Access Compliance Report

Public Rights-of-Way

Intersection ID: N/A	Main Street: SHOPTON_RD	Cross Street: DIXIE_RIVER_RD	Location: SW
ADA ID: 8A8A1D579BC1	Ramp Type: Perp	Initial Pass/Fail: Fail	Overall Compliance: No
		Severity Score: 22.5

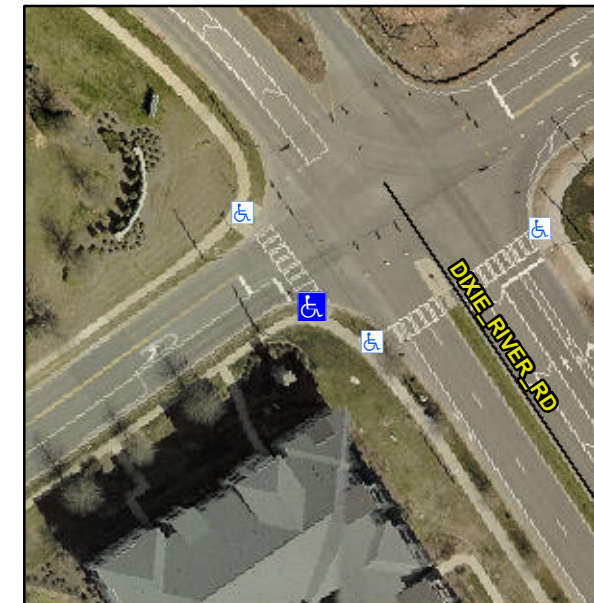
Not Found, R304.5.1, R304.2.2, R304.5.3

Compliance	Description	Data	Compliance	Description	Data
N/A	Ramp Length (in)	46.5	No	Ramp Slope (%)	9.2
No	Ramp Width (in)	47.0	No	Ramp XSlope (%)	2.1
N/A	Flare Type LT	N/A	N/A	Flare Type RT	N/A
N/A	Flare Slope LT (%)	N/A	N/A	Flare Slope RT (%)	N/A
N/A	Flare Traversable LT?	N/A	N/A	Flare Traversable RT?	N/A
N/A	Landing Length (in)	N/A	N/A	DWS Provided?	N/A
N/A	Landing Width (in)	N/A	N/A	DWS Contrast?	N/A
N/A	Landing Slope (%)	N/A	N/A	DWS Length (in)	N/A
N/A	Landing X Slope (%)	N/A	N/A	DWS Full Width?	N/A
N/A	Landing Curb? (Y/N)	N/A	N/A	DWS Offset (in)	N/A
N/A	Shared Landing?	N/A			
N/A	Gutter Ponding?	N/A	N/A	Gutter Slope (%)	N/A
N/A	Gutter Lip Ht (in)	N/A	N/A	Gutter X Slope (%)	N/A
N/A	Painted X Walk1?	Yes	N/A	Painted X Walk2?	N/A
	X Walk 1 Direction	To NW		X Walk 2 Direction	N/A
N/A	X Walk 1 Width (in)	116.0	N/A	X Walk 2 Width (in)	N/A
	X Walk 1 Slope (%)	1.4		X Walk 2 Slope (%)	N/A
	X Walk 1 X Slope (%)	1.5		X Walk 2 X Slope (%)	N/A

Remove & Replace Entire Ramp.
